Access Compliance Report

Public Rights-of-Way

Intersection ID: 14299	Main Street: N_I-77_EXIT_8_RA	Cross Street: REMOUNT_RD	Location:	E
ADA ID: AA7862305838	Ramp Type: PerpDiag	Initial Pass/Fail: Fail	Overall Compliance: No	Severity Score: 50
Codes/Mitigation Info/Possible Solution		Field Measurements/Component Compliance

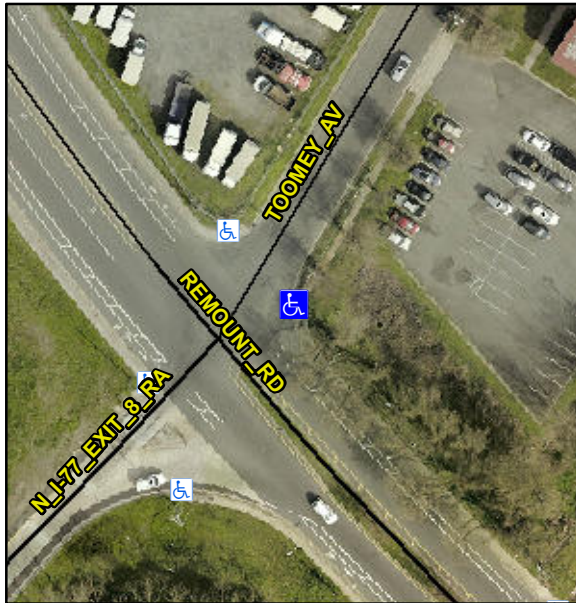
Not Found, R304.2.2, R304.5.3

Compliance	Description	Data	Compliance	Description	Data
N/A	Ramp Length (in)	58.0	No	Ramp Slope (%)	14.6
Yes	Ramp Width (in)	48.0	No	Ramp XSlope (%)	11.1
N/A	Flare Type LT	N/A	N/A	Flare Type RT	N/A
N/A	Flare Slope LT (%)	N/A	N/A	Flare Slope RT (%)	N/A
N/A	Flare Traversable LT?	N/A	N/A	Flare Traversable RT?	N/A
N/A	Landing Length (in)	N/A	N/A	DWS Provided?	N/A
N/A	Landing Width (in)	N/A	N/A	DWS Contrast?	N/A
N/A	Landing Slope (%)	N/A	N/A	DWS Length (in)	N/A
N/A	Landing X Slope (%)	N/A	N/A	DWS Full Width?	N/A
N/A	Landing Curb? (Y/N)	N/A	N/A	DWS Offset (in)	N/A
N/A	Shared Landing?	N/A			
N/A	Gutter Ponding?	N/A	N/A	Gutter Slope (%)	N/A
N/A	Gutter Lip Ht (in)	N/A	N/A	Gutter X Slope (%)	N/A
N/A	Painted X Walk1?	No	N/A	Painted X Walk2?	No
	X Walk 1 Direction	To NW		X Walk 2 Direction	To SW
N/A	X Walk 1 Width (in)	N/A	N/A	X Walk 2 Width (in)	N/A
	X Walk 1 Slope (%)	0.9		X Walk 2 Slope (%)	4.4
	X Walk 1 X Slope (%)	5.8		X Walk 2 X Slope (%)	3.2

Remove & Replace Curb Ramp With Two New Directional Ramps or Equivalent.
